**Request for Additional Information No. 338 (4077),
Question 03.06.03-27**

U. S. EPR Standard Design Certification

SRP Section: 03.06.03 - Leak-Before-Break Evaluation Procedures

Question 03.06.03-27:**Follow-up Question to RAI No. 265, Question 03-06-03-24**

Figure 03.06.03-27-1: Comparison of Load Points on the MSL for ALL with SF=2.0

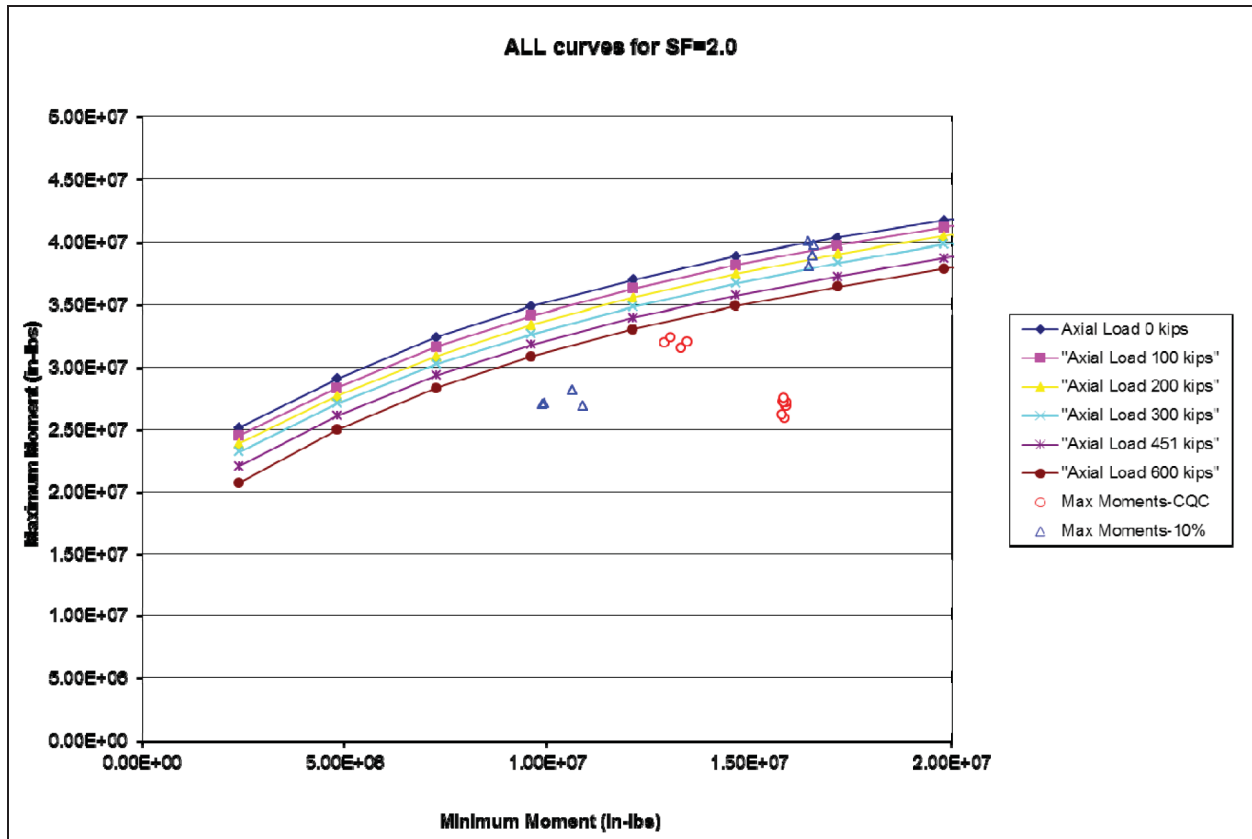
In response to RAI question 03.06.03-24, AREVA stated that the safety factor of 1.7 for dynamic loads to be applied for leak-before-break (LBB) of the main steam line will be revised to 2.0 due to a decrease in seismic loads based on the application of more accurate, but still conservative, methods of modal combinations as described in RG 1.92 Revision 2. Please provide an explanation as to how using RG 1.92 Revision 2, it was able to achieve the LBB dynamic safety factor of 2.0 for its main steam piping. Specifically, discuss which modal combination method was used previously and which modal combination was used that resulted in lower seismic loads. Also, provide a comparison of the seismic loads for both of these methods.

A comparative plot of maximum moments versus the allowable load limit (ALL) curve for both analyses is provided in Figure 03.06.03-27-1. This plot provides a qualitative understanding of load reduction due to the changes in modal combination methods as well as the support configuration. The load points shown in the figure are for the highest loaded locations using the

ten percent and the CQC methods. Since the load points are enveloped by the ALL curves, a safety factor of 2.0 provides acceptable results for the qualification of LBB for the MSL.

This response has been revised to update the comparison Figure 03.06.03-27-1 for the MSLs due to changes in the seismic analysis of the steam lines.

There are no changes to the modal combination methods used in the seismic analysis of the pipe as discussed in the response above. Figure 03.06.03-27-1 has been updated to reflect the new LBB loads comparison. The conclusion of the comparison remains unchanged; the MSL analysis is qualified for LBB.
